CONTRACT:	Hammerstone Road	CONTRACT NO:	232	DATE:	30.10.23.
------------------	------------------	---------------------	-----	--------------	-----------

METHOD STATEMENT No.	014	REV.	B
TITLE	Connection Manholes	LOCATION	MH S06 and MH S08
START DATE	30.10.23.	DURATION	36 weeks overall duration

Application details:	Application number: CDN/25/0113 Proposal: Discharge of condition 11 (drainage) attached to planning permission referenced 137572/JO/2023 Location: Hammerstone Road Depot, Hammerstone Road, Manchester, M18 8EQ
-----------------------------	---

PROPOSED LOWER FLOOR DRAINAGE

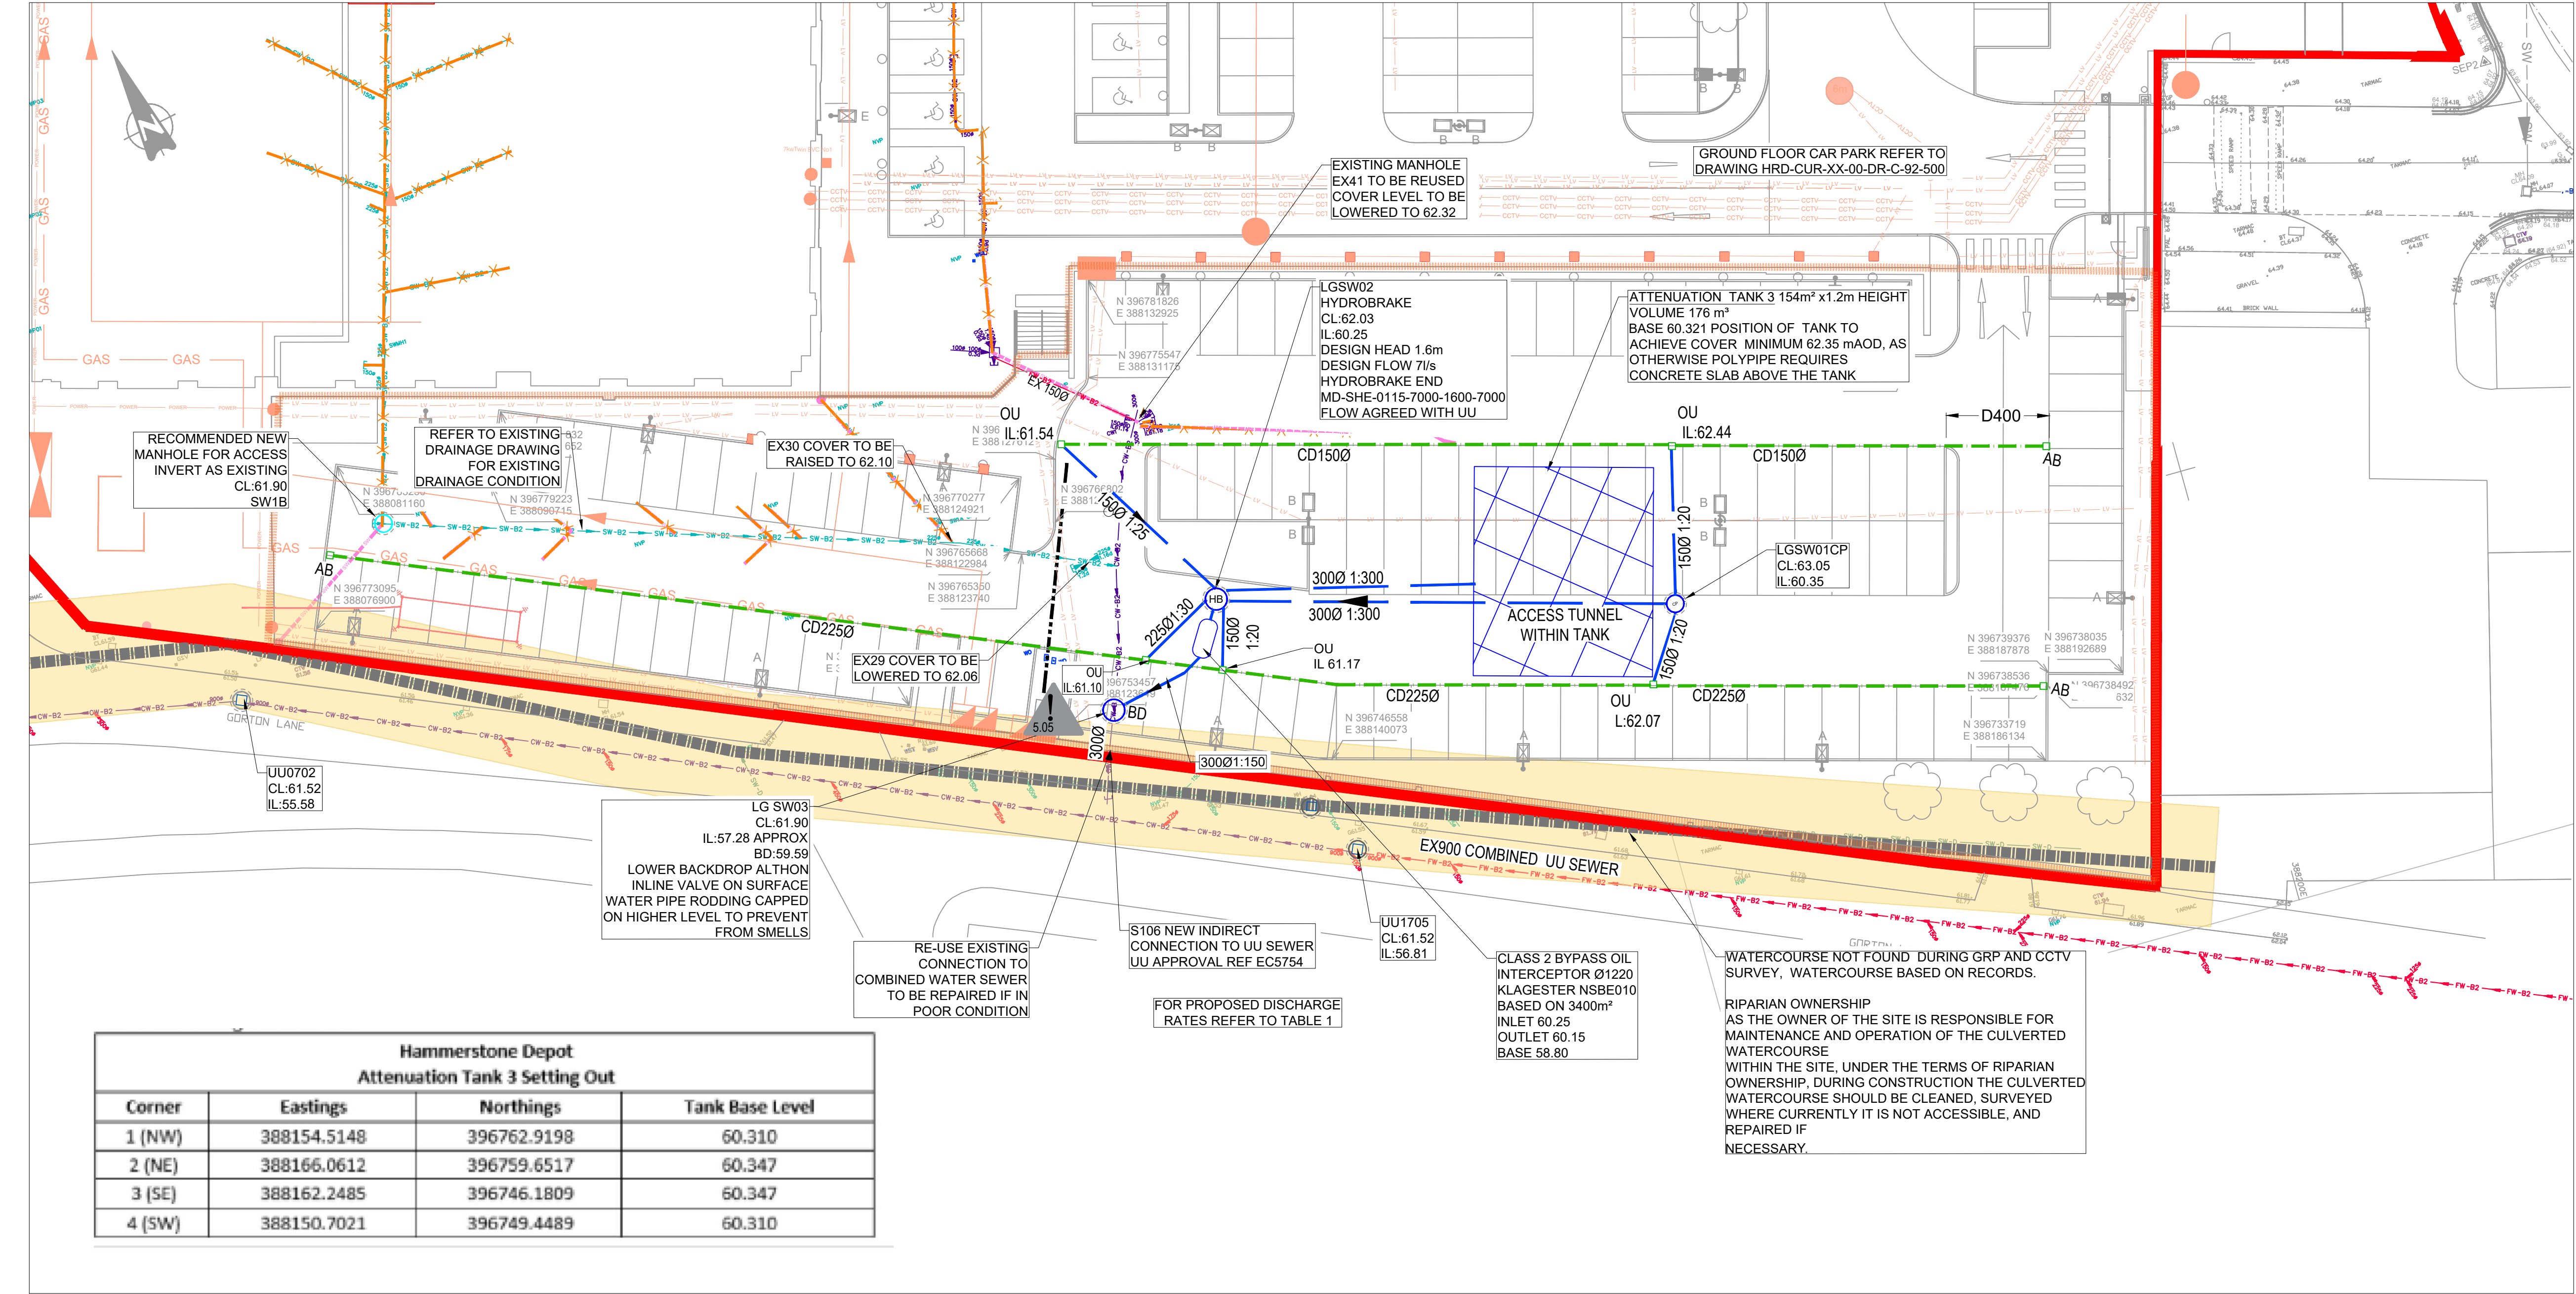
INFORMATION PROVIDED BY THE CCTV SURVEY DID NOT PROVIDE CONFIRMATION WHERE SOUTH WATERCOURSE IS LOCATED

ATTENUATION TANK 3
3 x 400mm LAYERS OF POLYSTORM PSM1/ POLYSTORM INSPECT PSM4 (400mm DEEP)
BASED ON APPROXIMATE MINIMUM BURIAL DPTH OF 2.81m

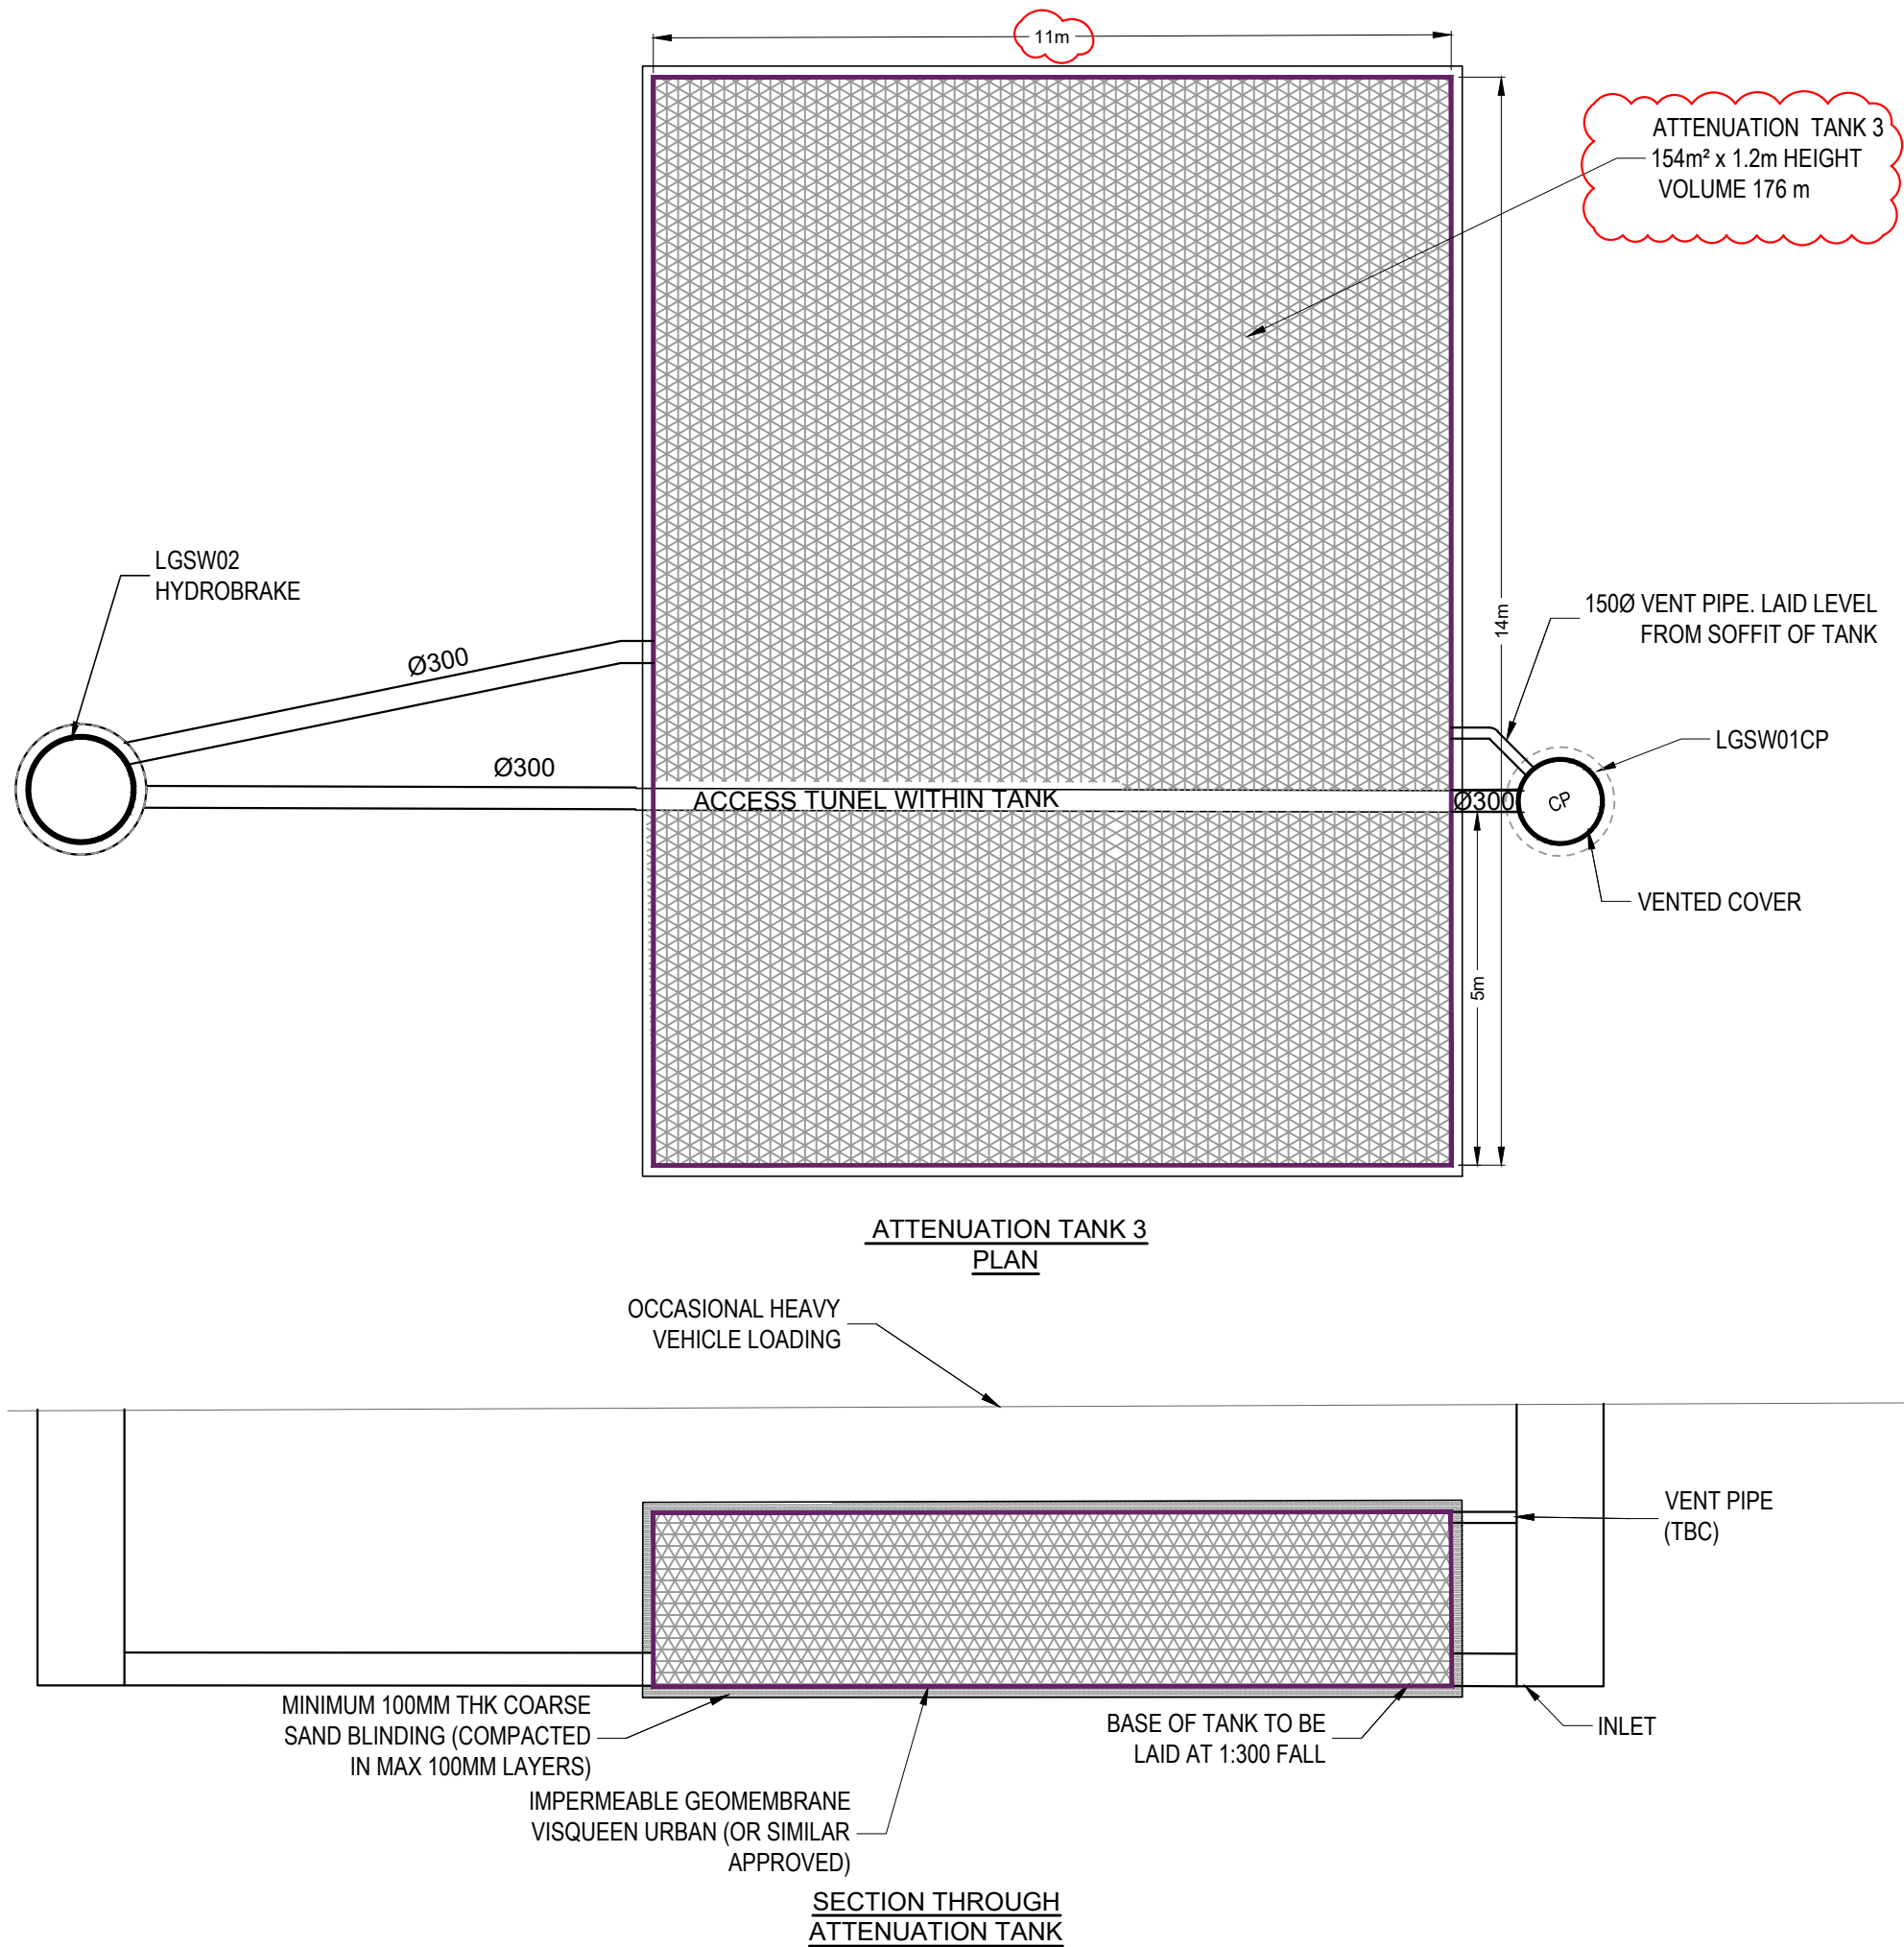
HIGH GROUNDWATER LEVEL ESTIMATED AT 60.44 BASED ON SITE INVESTIGATION (CP01). INITIAL FLOATATION CALCULATIONS INDICATE THAT THE TANK IS NOT AT RISK OF FLOATATION. HOWEVER, THE MAUFACTURER SHOULD PROVIDE CALCULATIONS TO CONFIRM THIS.
